Drainage Summary Report

Desert Willow Family School

**RE: APS Family School East Side
3303 Monroe St NE
Drainage Plan and Report
Engineer's Stamp Date: 1/30/2017 & 12/12/2016
Hydrology File: G17D019A**

From: Carrillo, Abiel X. [mailto:acarrillo@cabq.gov]
Sent: Tuesday, December 27, 2016 4:33 PM
To: Dave Aube <daube@designgroupnm.com>
Subject: APS East Side Family School - G17D19A - Stamp Date 12-12-2016

Rectangular Weir

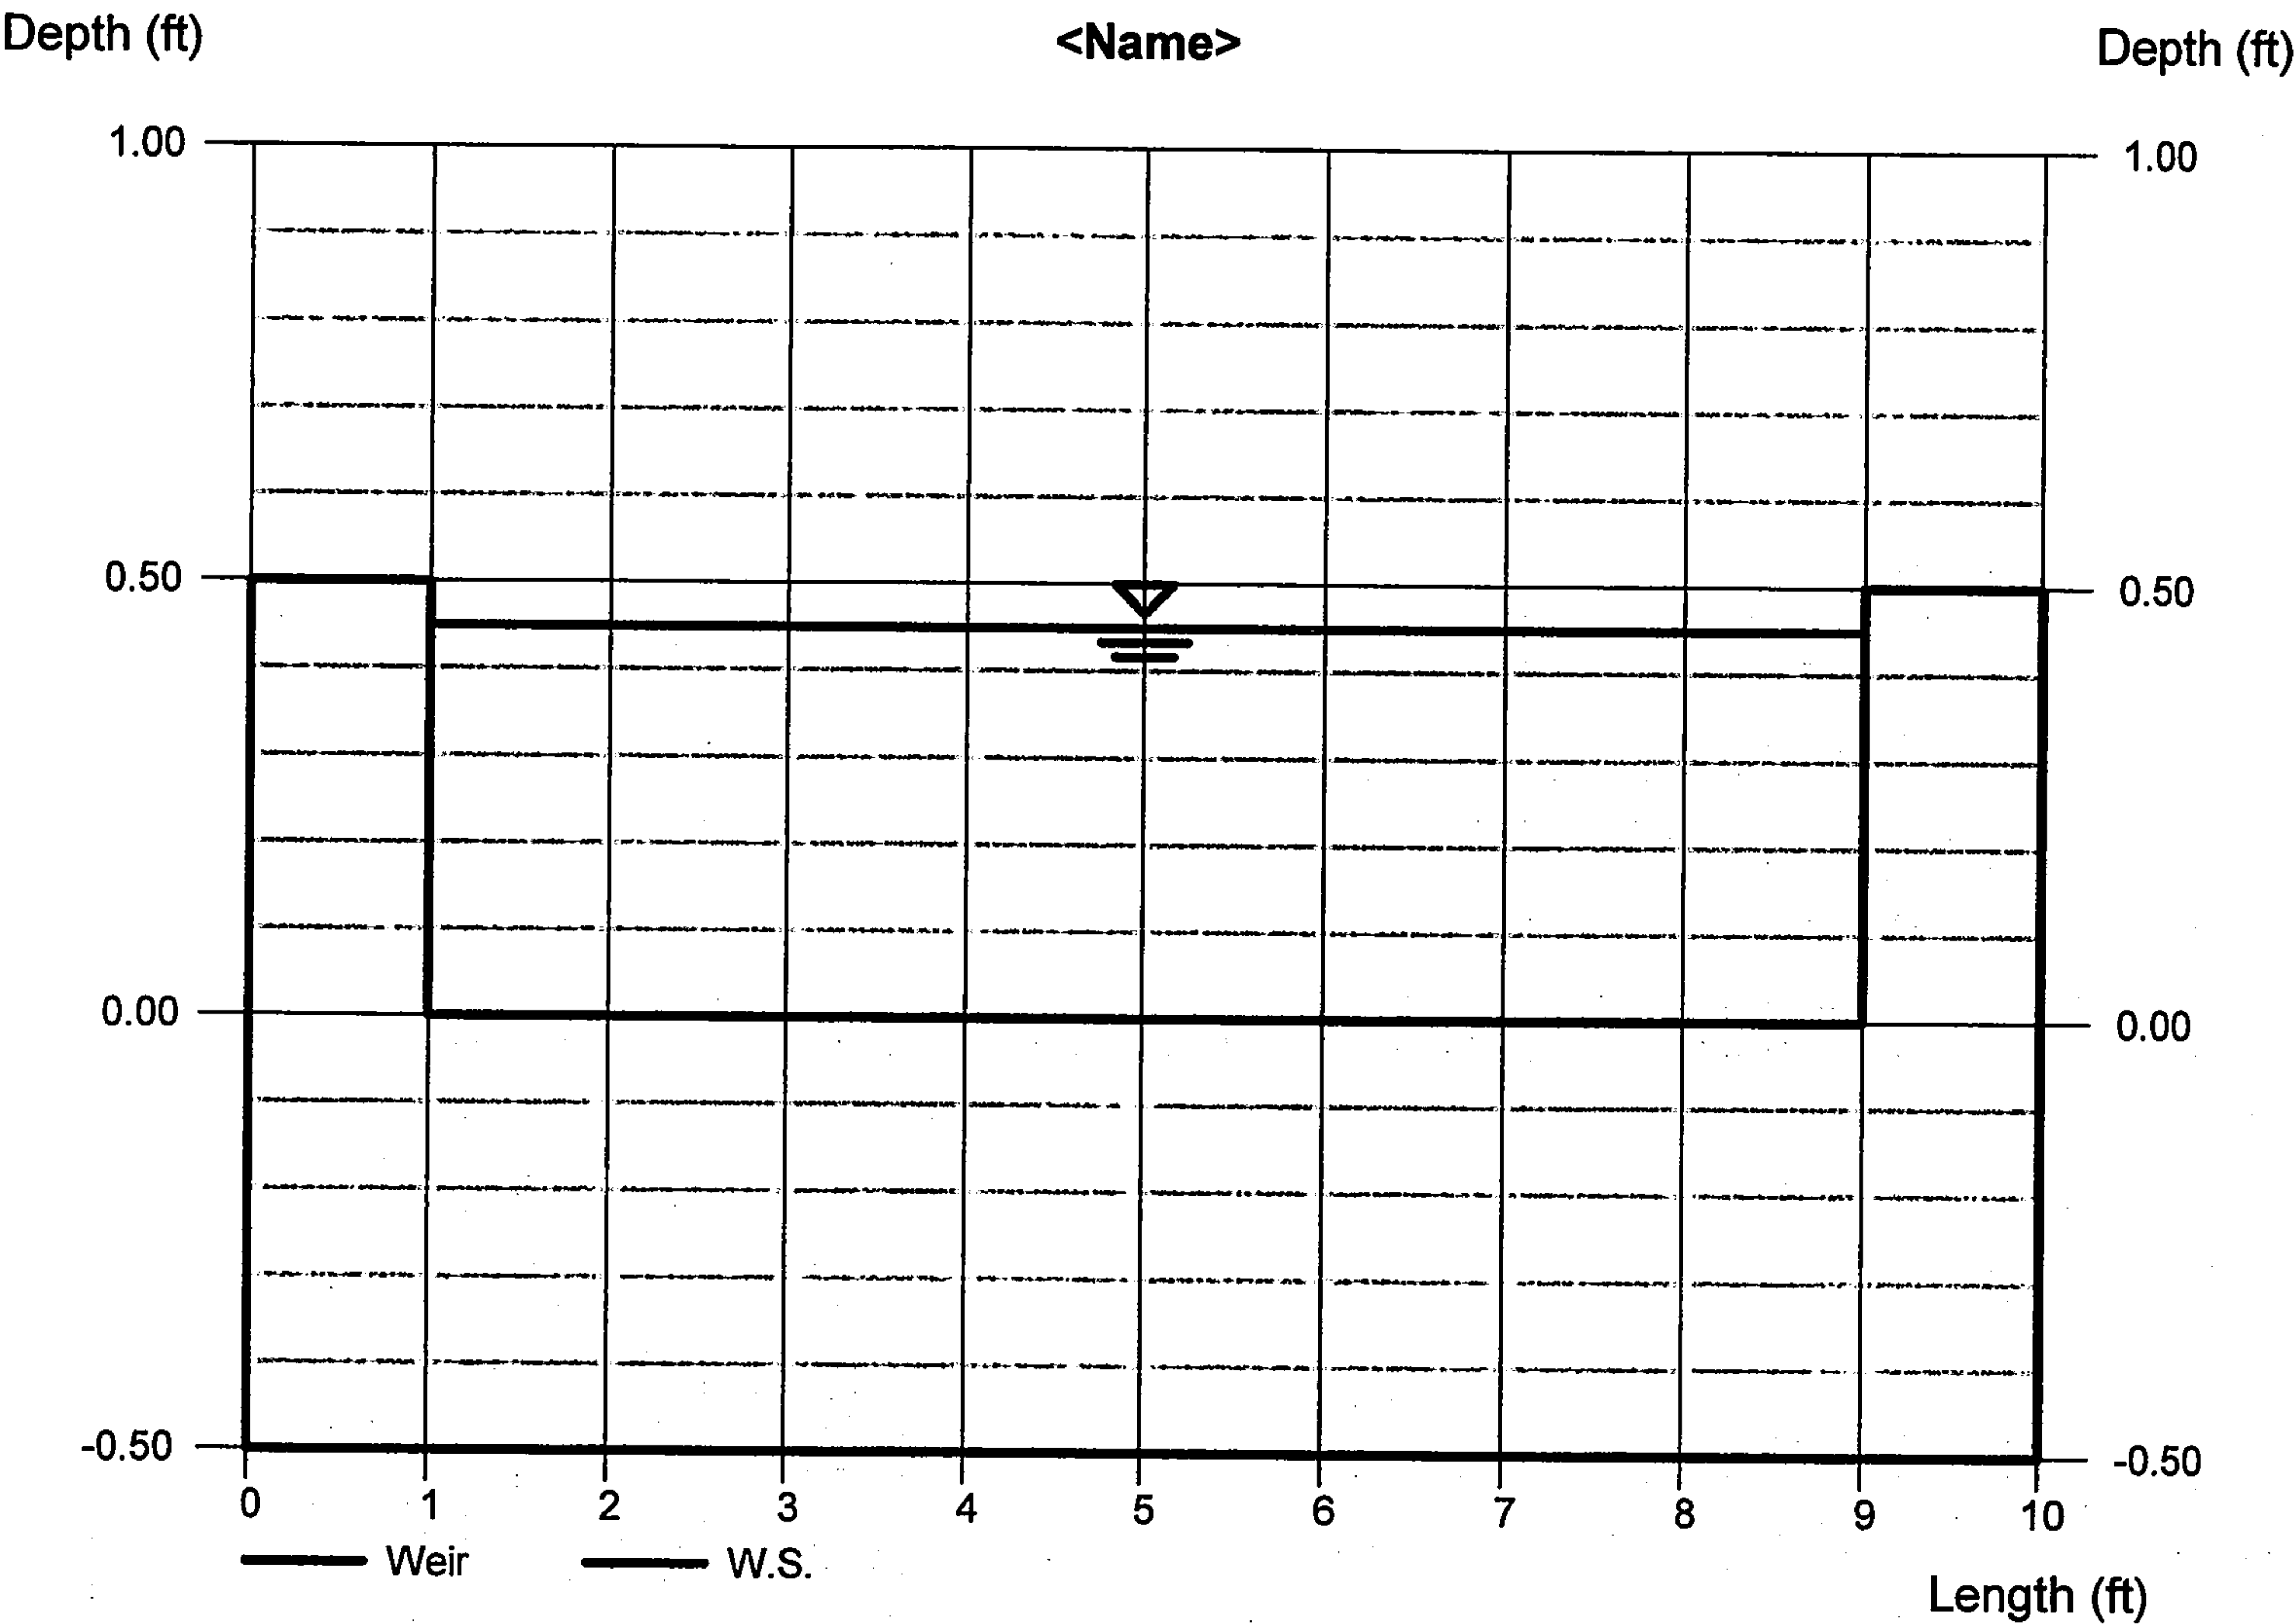
1. Define the limits of construction and provide area. Submittal of an erosion and sediment control plan is required prior to building permit approval if the disturbed area is over 1 acre. Please contact Curtis Cherne P.E at 924-3420 for question regarding ESC plans.
2. Clarify how the storm drain outfalls through the wall and into the pond with a detail view/notes and include dimensions and inverts. In your previous submittal, this information was added for the overflow weir, but not the storm drain outfall.

1. Use RVP Class IV underneath the building and the wall
2. Call out Section and detail views for the weir
3. Correct invert elevation on SD Manhole #2

9. Provide information for the overflow rundown/weir from the above-mentioned pond (invert elevation, tie-in elevation). Information concerning the weir has been provided both on the plan and in the additional paperwork.

Rectangular Weir

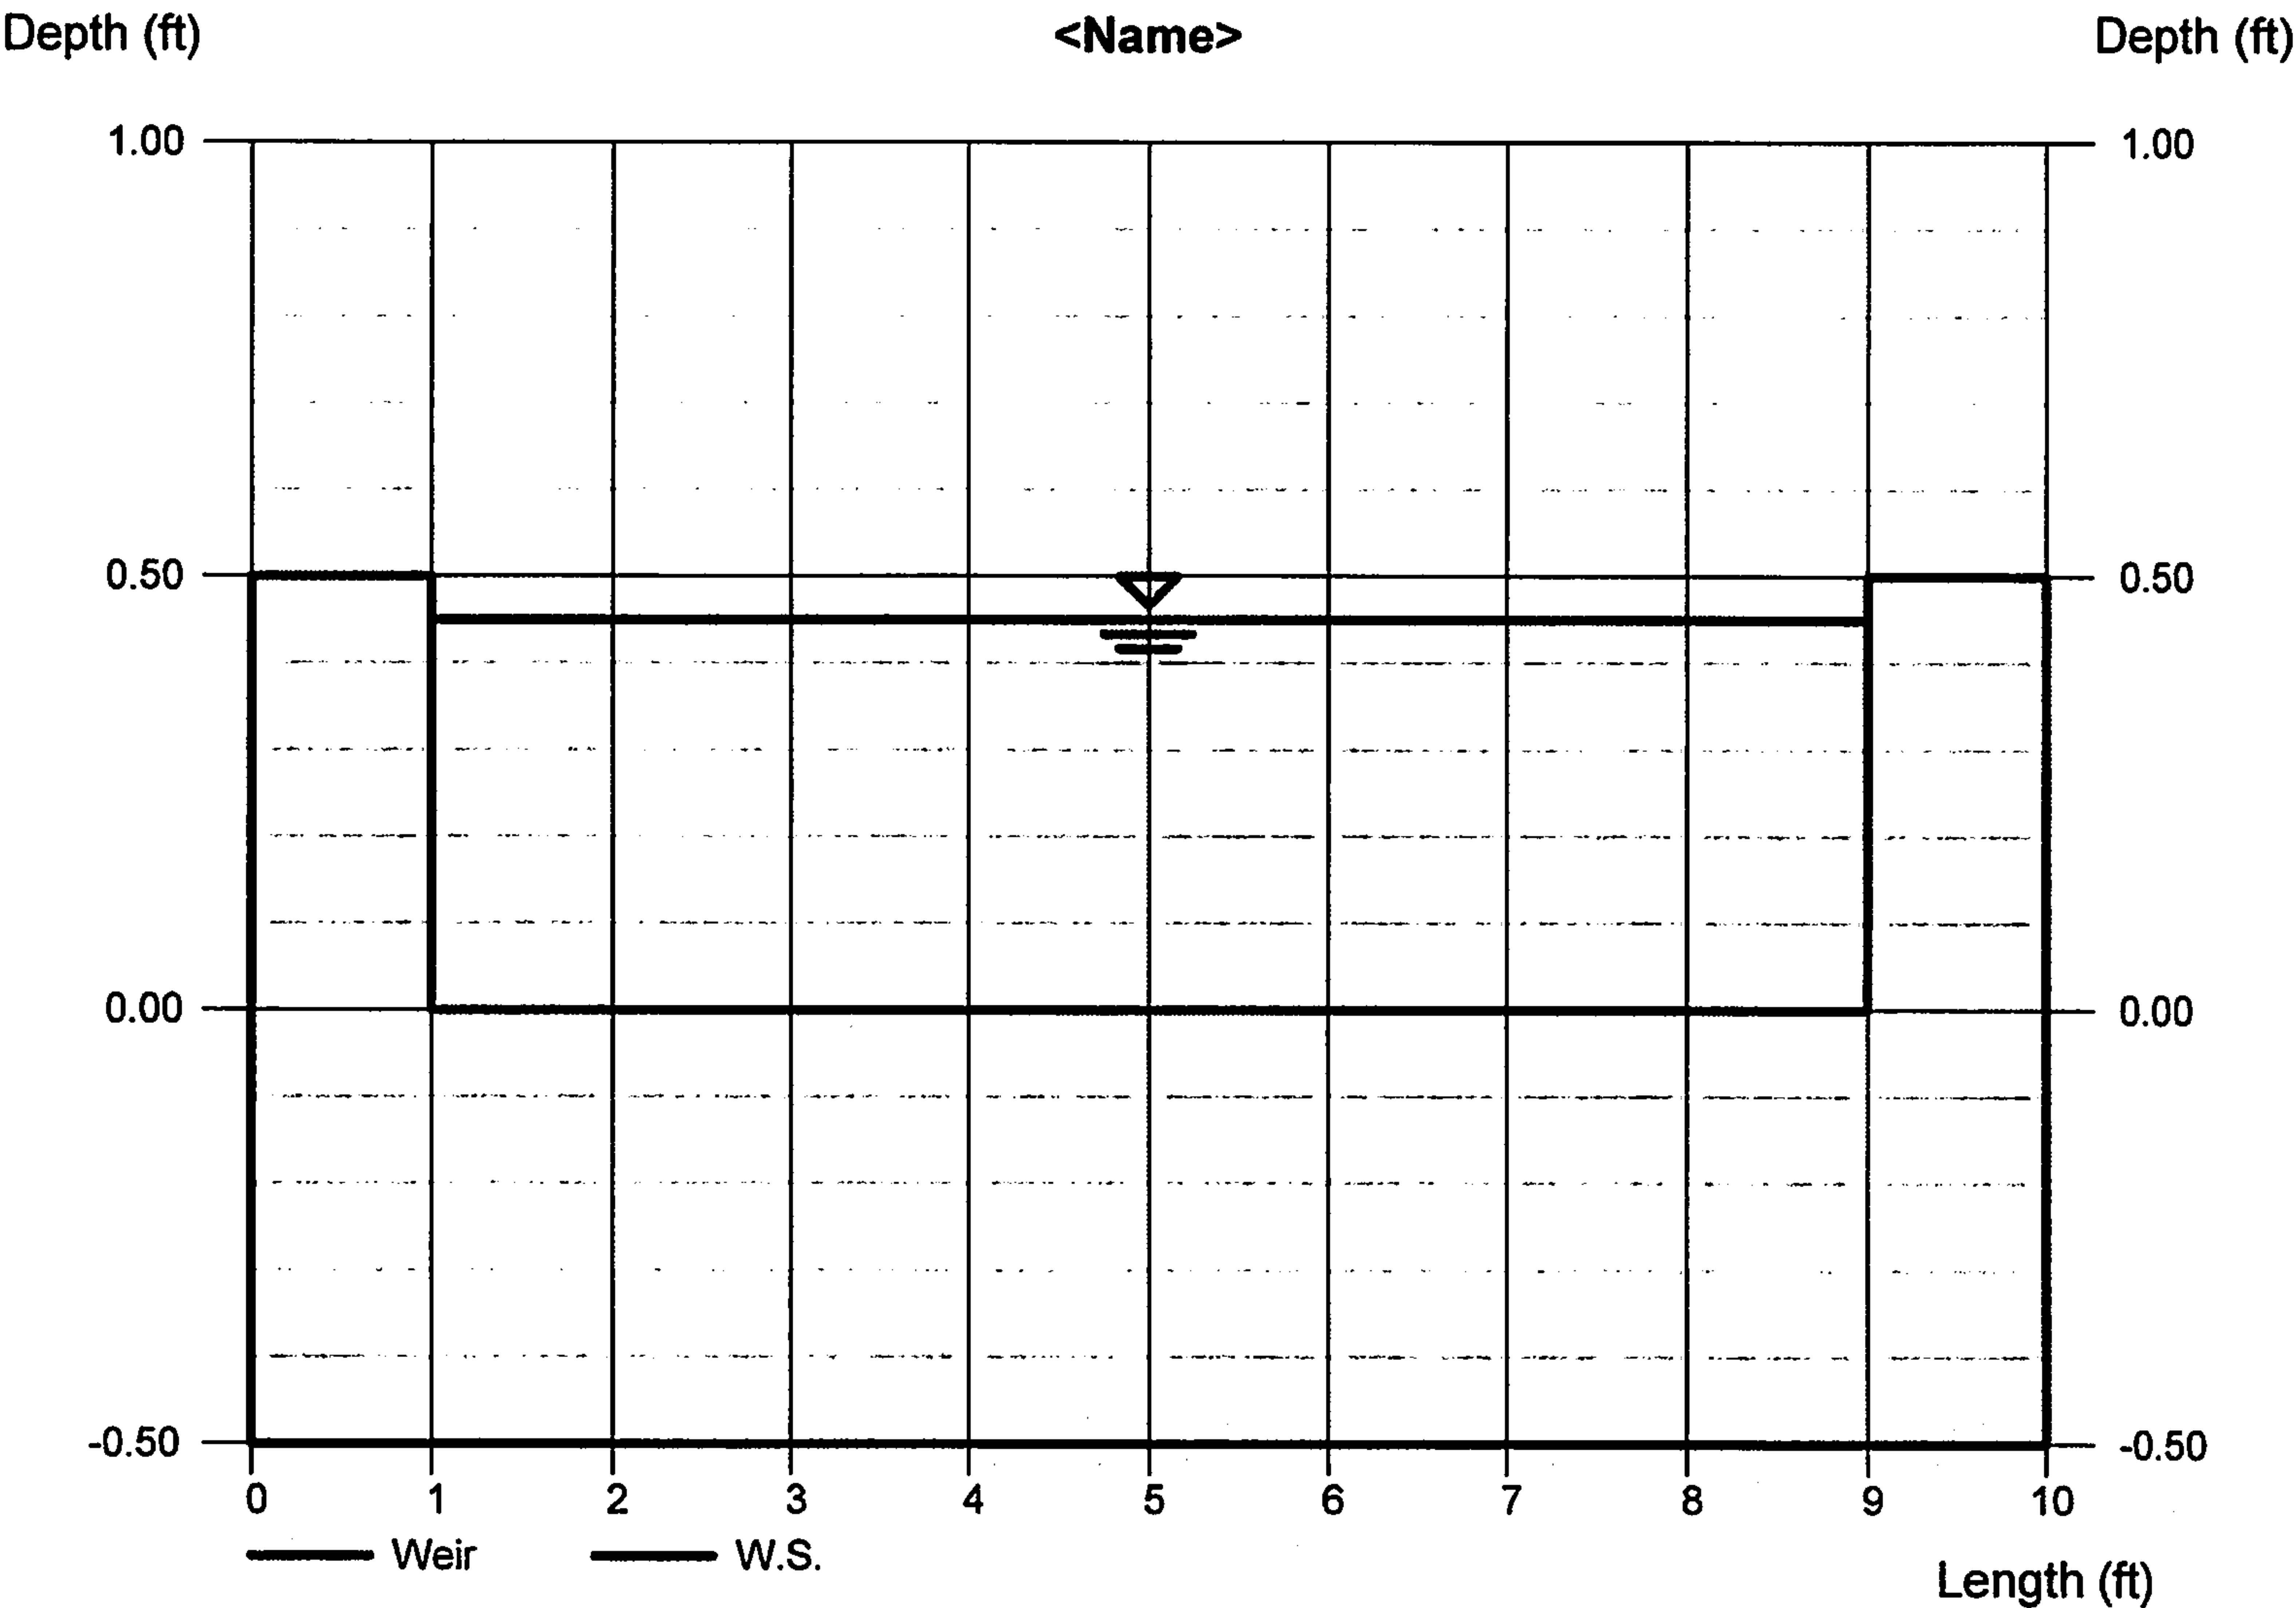
1. Define the limits of construction and provide area. Submittal of an erosion and sediment control plan is required prior to building permit approval if the disturbed area is over 1 acre. Please contact Curtis Cherne P.E at 924-3420 for question regarding ESC plans. *Area disturbed = 43,658. Plan submitted to Mr. Cherne.*
2. Clarify how the storm drain outfalls through the wall and into the pond with a detail view/notes and include dimensions and inverts. In your previous submittal, this information was added for the overflow weir, but not the storm drain outfall. *Details Added.*

1. Use RVP Class IV underneath the building and the wall
2. Call out Section and detail views for the weir
3. Correct invert elevation on SD Manhole #2 *(Thank you for noticing).*
